Corning Sub-basin GSA Committee Meeting Materials

April 11, 2024 | 2:00 p.m.

6. 2:15 p.m. Public Hearing: Adoption of the Revised Corning Subbasin Groundwater Sustainability Plan

Re: Corning Subbasin Groundwater Sustainability Plan

Cumulative Change in Groundwater Storage Corning Subbasin
Current and 2070 Condition from 1971

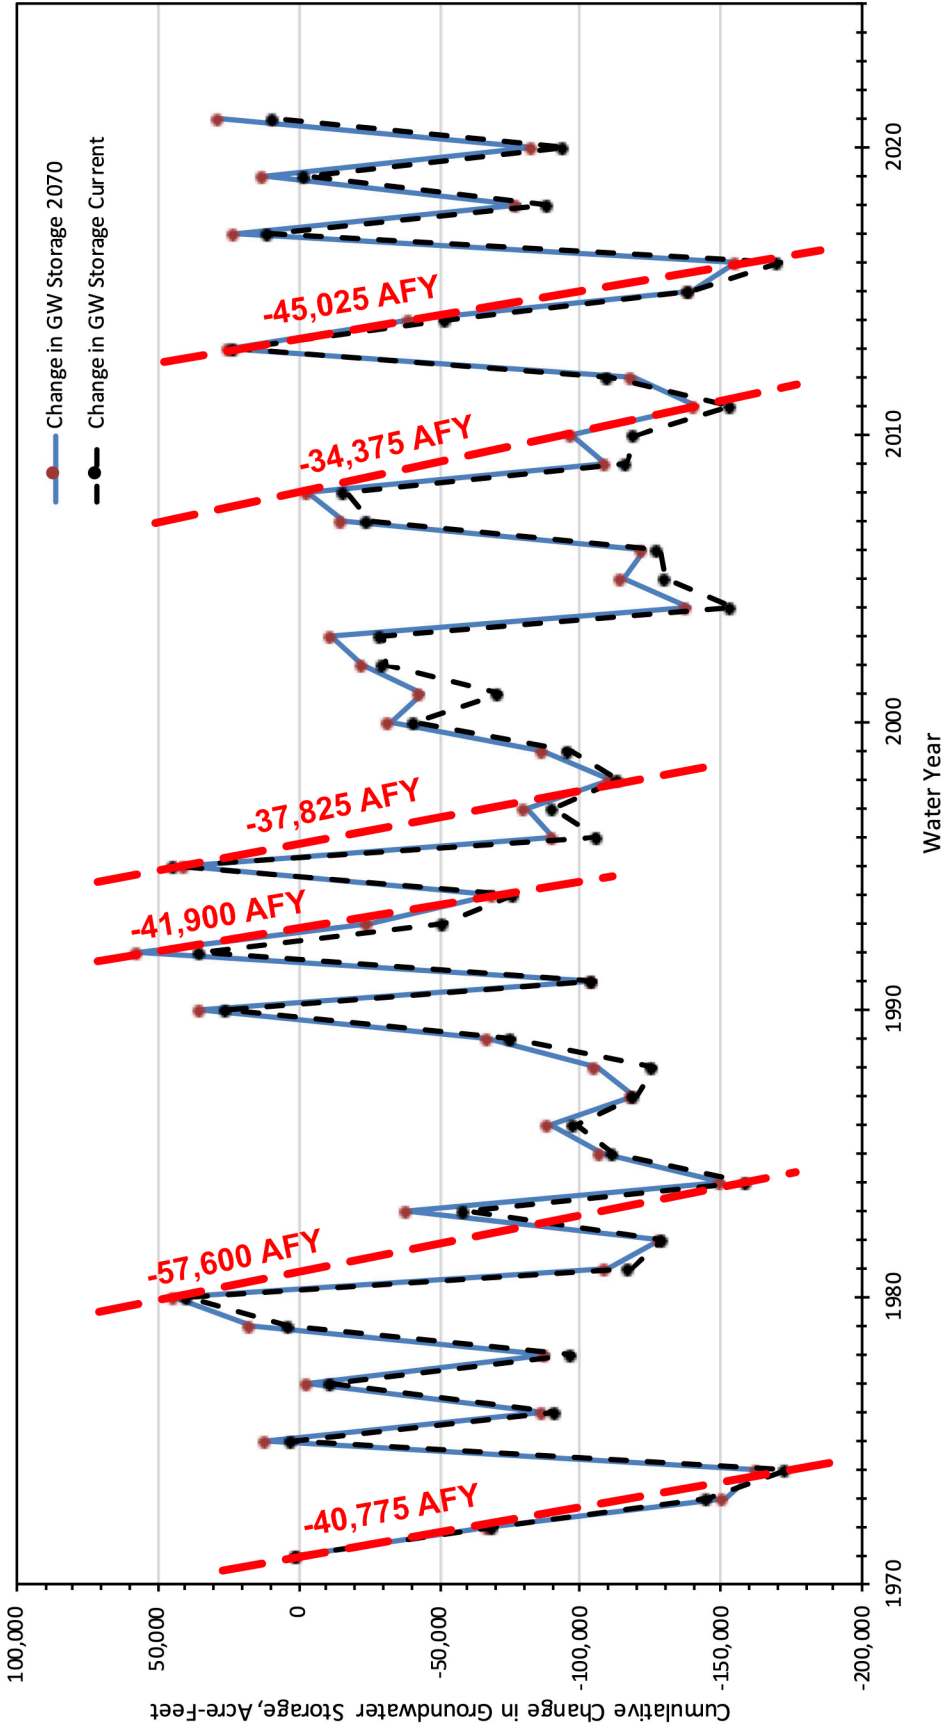
AquAlliance Exhibit 6 is a plot of the Current and Projected 2070 cumulative changes in groundwater storage based on the groundwater model of the Corning Subbasin. A table is included on the exhibit that lists values for the averages and three water year types for the Historical baseline, Current, and 2070 scenario water budgets, see AquAlliance Exhibits 1, 2 and 3. Lines are drawn on top of the cumulative change graphs that estimate the slope of the annual loss groundwater storage during droughts lasting 3 or more years. The estimated annual loss in storage ranges from -34,375 afy to -57,600 afy. The estimated average annual loss in groundwater storage for the 2070 scenario in CD/D water years falls within this range at -41,800 afy, AquAlliance Exhibit 2-1B (row 45, column D).

Subsidence in Agricultural Lands Within the Corning Subbasin

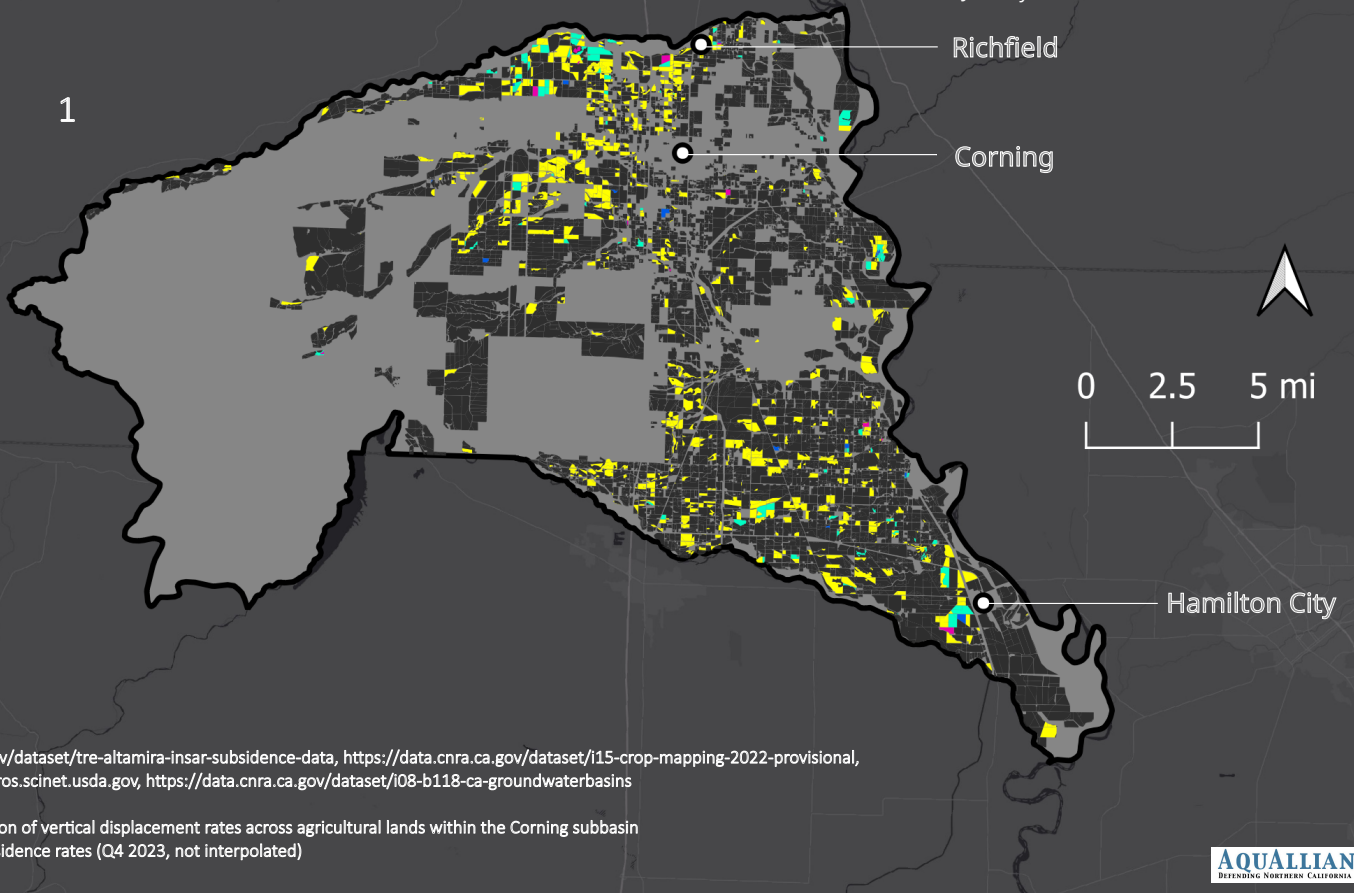
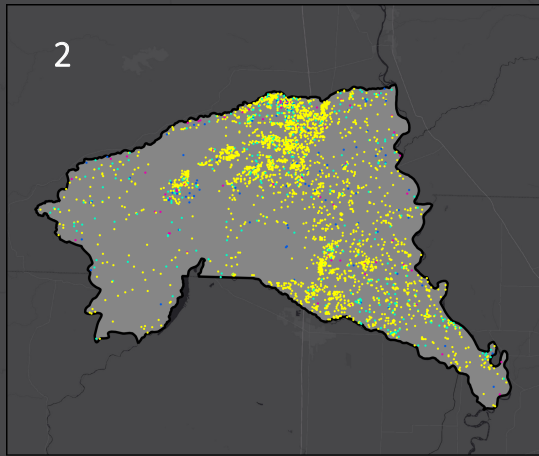
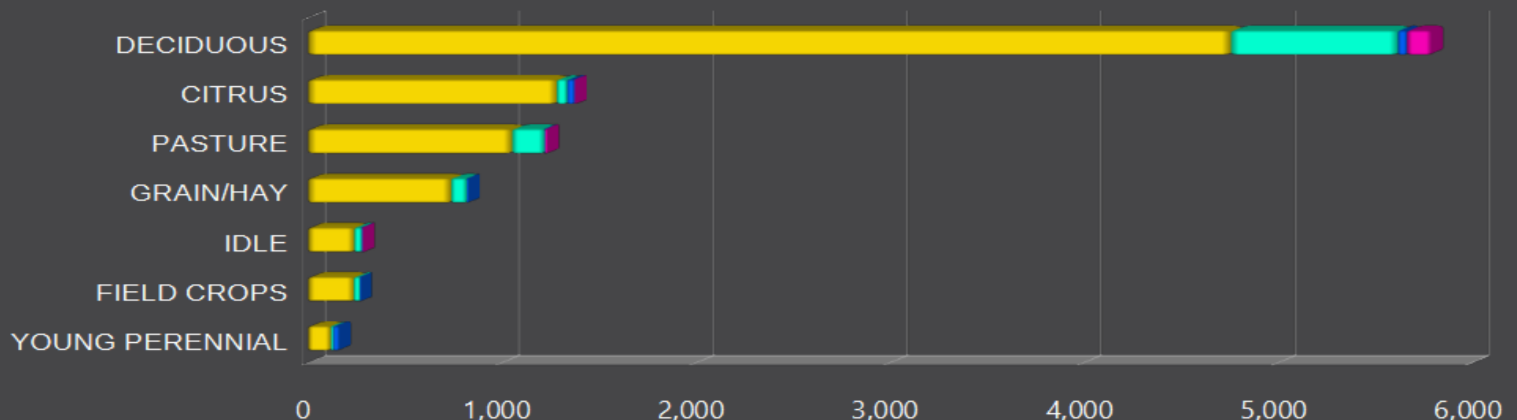
The MT rate for inelastic subsidence is 0.50 ft over 5 years, Table ES-1 and Sections 6.9.2 (pages 6-48, pdf 457). Although the Corning Subbasin has experienced little to no historical inelastic subsidence since the start of monitoring in 2004 (page 6-48, pdf 457), the MT was set *...to maintain consistency with neighboring subbasins*, Section 6.9.2.3 (pages 6-55 and 6-54, pdf 462 and 463). The neighboring subbasin to the south, Colusa Subbasin, has historically experienced inelastic subsidence and the MT for subsidence for that subbasin is also 0.5 feet over 5 years. Figure 6-11 shows the InSAR land subsidence data for the area at the southern border between the two subbasins surrounding Orland and Hamilton City (page 6-49, pdf 458). A north-south oriented area of subsidence ranging from -0.25 to -0.75 feet occurs just south of Orland. The Corning GSP indicates that groundwater pumping in the Colusa Subbasin near Orland has *...the potential to impact the ability of the Corning Subbasin GSAs to meet the subsidence minimum thresholds...* (page 6-54, pdf 463). Apparently, to be *consistent* with a neighboring subbasin that's experiencing ongoing subsidence, the Corning GSP will use the same MT, so that an undesirable result from subsidence doesn't have to be declared.
